VALVES MACH 16

New gasket and new screws for Mach 16 bases

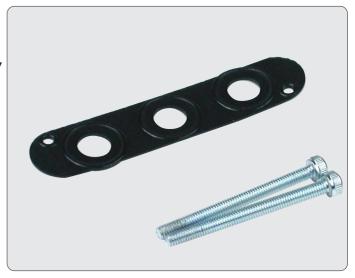
- A single gasket, remaining coupled to the base, instead of 5 O-rings
- Quicker and easier assembly
- Screw with hexagonal socket instead of cross grove
- Easy to screw.
- Possible to use pneumatic or electric screw drivers

Base, screws and seals are in the same kit. So there is no problem of interchange.

Has been added a new "base gasket kit for Mach 16" code 0226007003, in addition to the one with code 0226007001, that is still valid as spare part for old bases.
